*Nomad***SERVICE BULLETIN**

SUBJECT: ADDITIONAL SUPPORT FOR WINDOW SECURITY (MODIFICATION N481)

Fuselage Windows  
Installation of Mod N481  
Figure 1

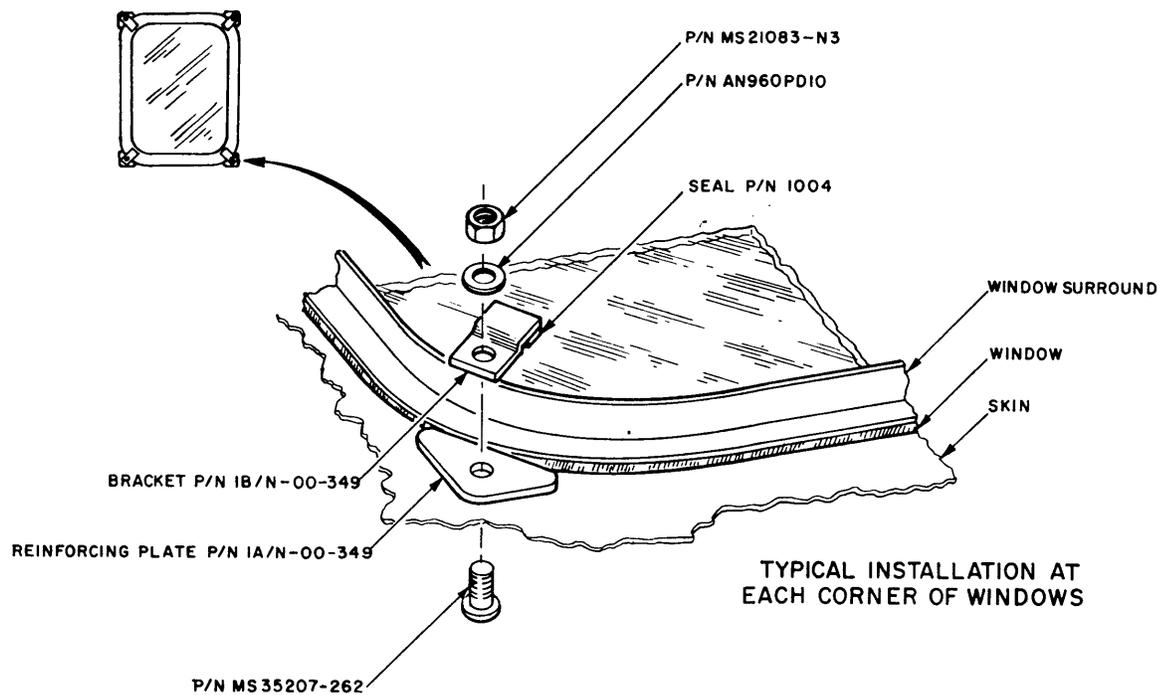
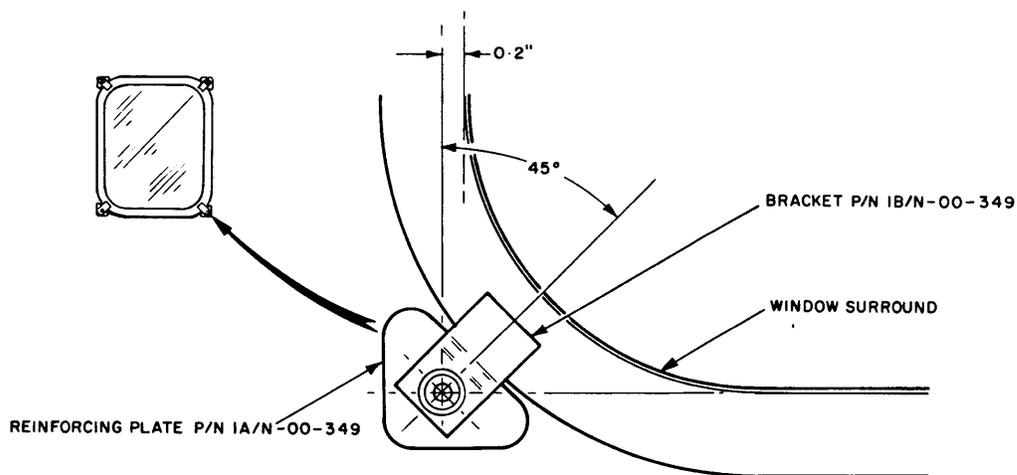
- (6) Position a reinforcing plate P/N 1A/N-00-349 at each corner as shown in Figure 1 and attach it to the fuselage skin using commercial araldite or a suitable adhesive.

- (7) In turn, correctly position the four brackets P/N 1B/N-00-349 (Ref Figure 1) and drill a 5.0 mm diameter hole through the reinforcing plate and fuselage skin using the 5.0 mm diameter hole in the bracket as a drill guide.

- (8) Attach a strip of self-adhesive PVC foam tape (Unisil P/N 1004) across the width of each bracket (Ref Figure 1) and secure the brackets using the attaching parts shown in Figure 1. Torque tighten the nuts to between 15 and 20 lb in above torque value required to overcome the friction of the nut insert.

Air Stair Door Assembly  
Installation of Mod N481  
Figure 2

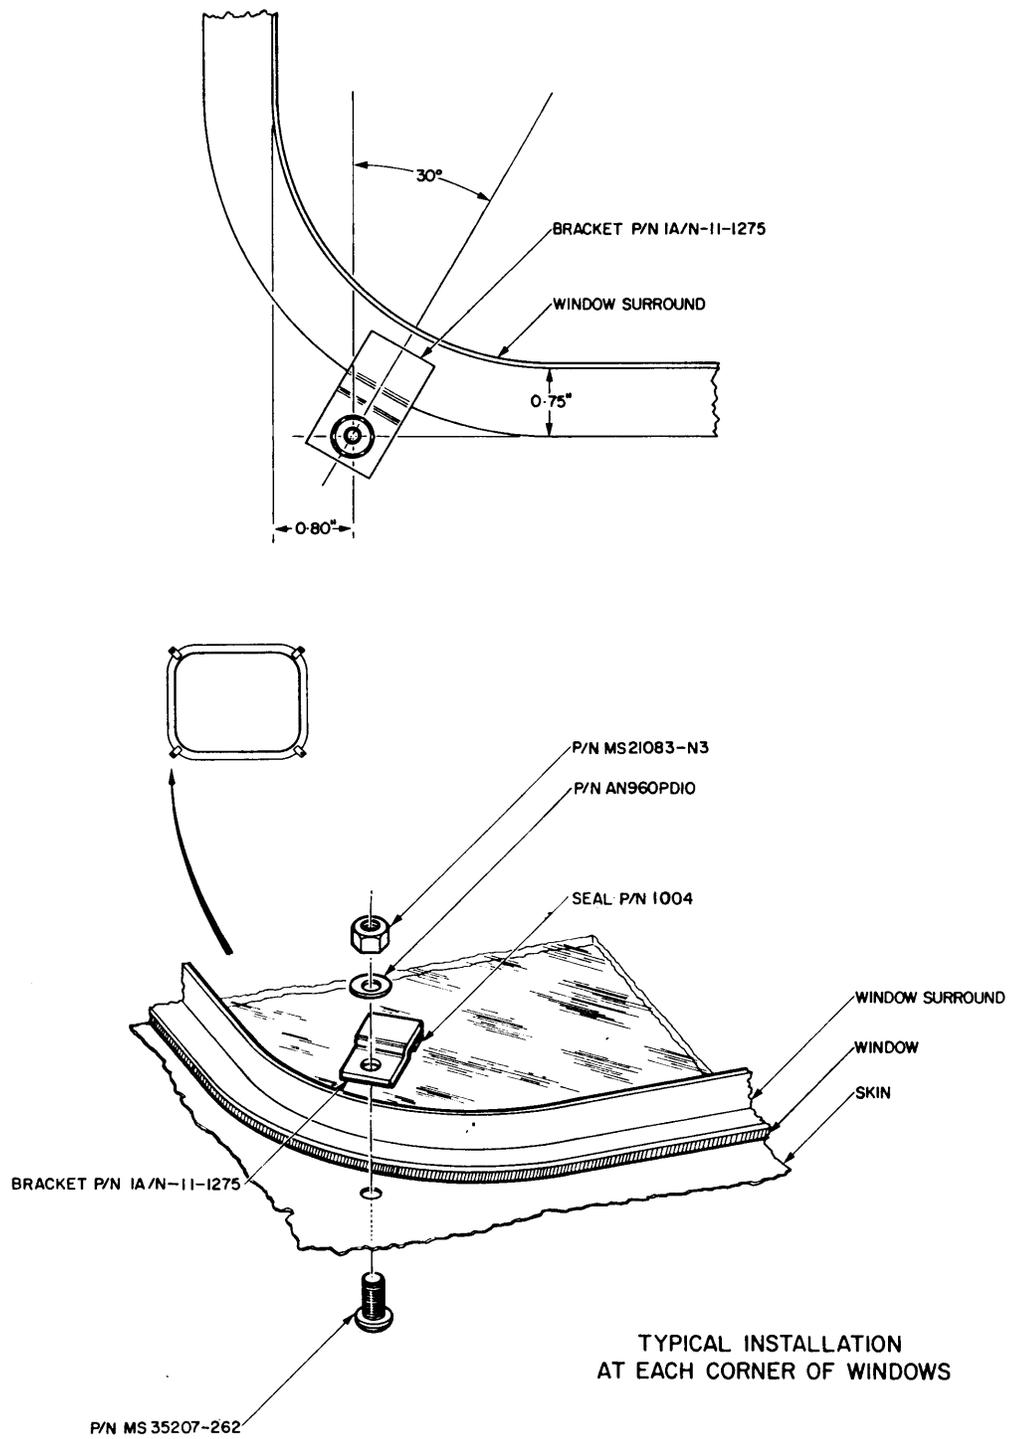
- (5) Position a reinforcing plate P/N 1A/N-00-349 at each corner of the window as shown in Figure 2 and attach it to the door skin using commercial araldite or a suitable adhesive.

- (6) In turn, correctly position the four brackets P/N 1B/N-00-349 (Ref Figure 2) and drill a 5.0 mm diameter hole through the reinforcing plate and door skin using the 5.0 mm diameter hole in the bracket as a drill guide.

- (7) Attach a strip of self-adhesive PVC foam tape (Unisil P/N 1004) across the width of each bracket (Ref Figure 2) and secure the brackets using the attaching parts shown in Figure 2. Torque tighten the nuts to between 15 and 20 lb in above torque value required to overcome the friction of the nut insert.
